Product/Process Change Notice (PCN)

PCN #: PCN_AsSMSx_20141117
Product Affected: WA-SMST 9774030960R
WA-SMSI 9774030360R

Packaging will be changed. Effective date code beginning with 2015-02-28.

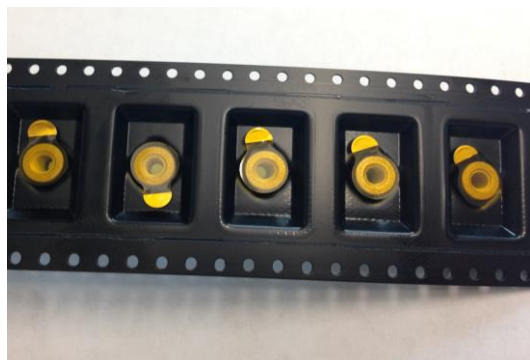
We change the reel width from 32mm to 24mm, to increase the capacity of the reel.
The packaging unit per reel will be changed from 650 to 800pcs.
Please take care of the new drawing of the reel.
